ADVISORY
 BULLETIN

No. 2000-14
(Mercury Jet Drives No. 2000-02)

Hard Starting - 240 EFI M² Jet Drive

240 EFI M² Jet Drive

a - Disconnect TAN/BLACK Leads

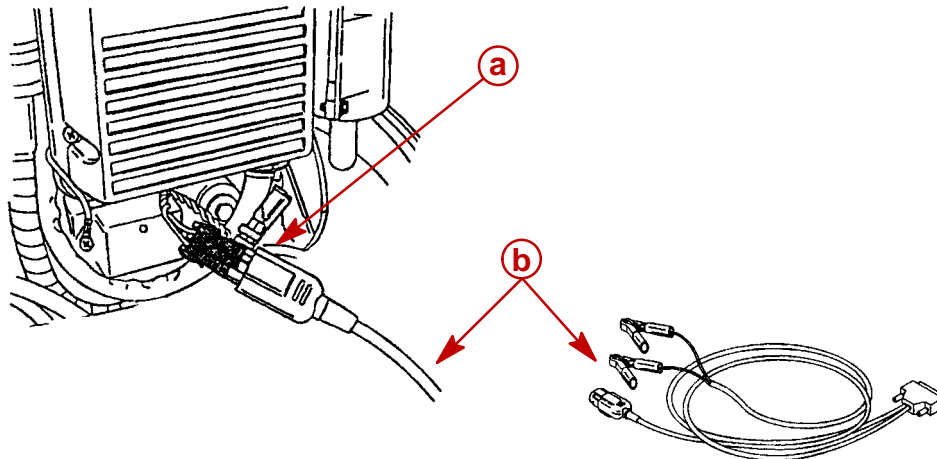
- Disconnect the TAN/BLACK lead wire from the temperature sensor and then start the engine. If this resolves the hard start condition, follow the corrective action described below.

a - ECM Diagnostic Port

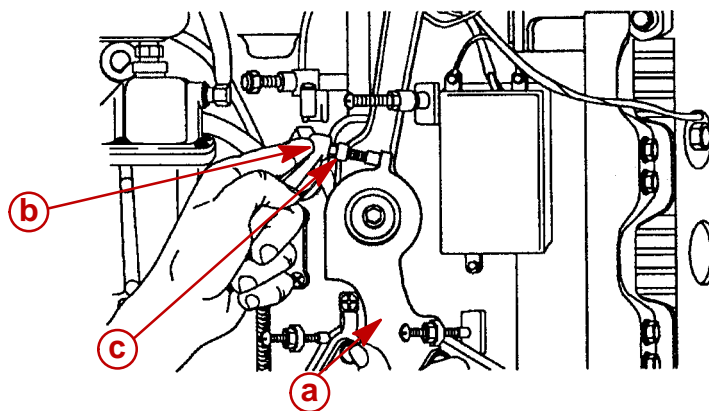
- Connect the DDT tester (91-823686A2) with cartridge (91-822608-6) to engine using the adaptor cable (84-822560A5). Refer to DDT Tech manual (90-825159-2) for detailed instructions (p. 52).

- a** - Throttle Arm
- b** - Idle Timing Screw
- c** - Locknut

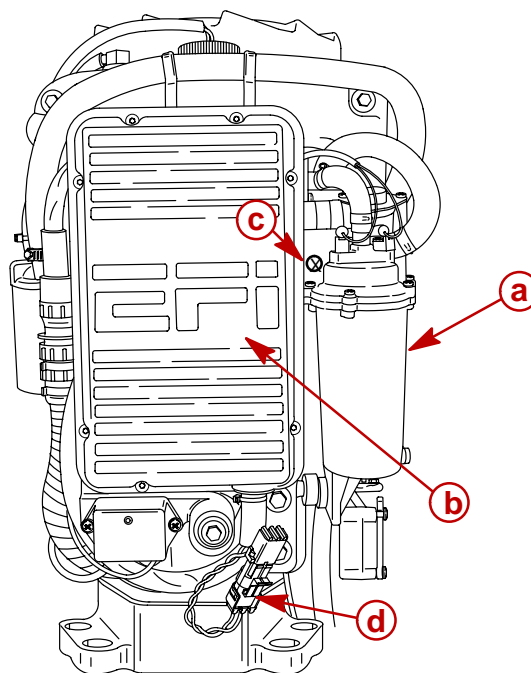
- With the DDT attached and engine idling: Hold throttle arm against idle stop (throttle cable barrel removed from barrel retainer). Adjust idle timing screw to 10 degrees BTDC. Tighten locknut.
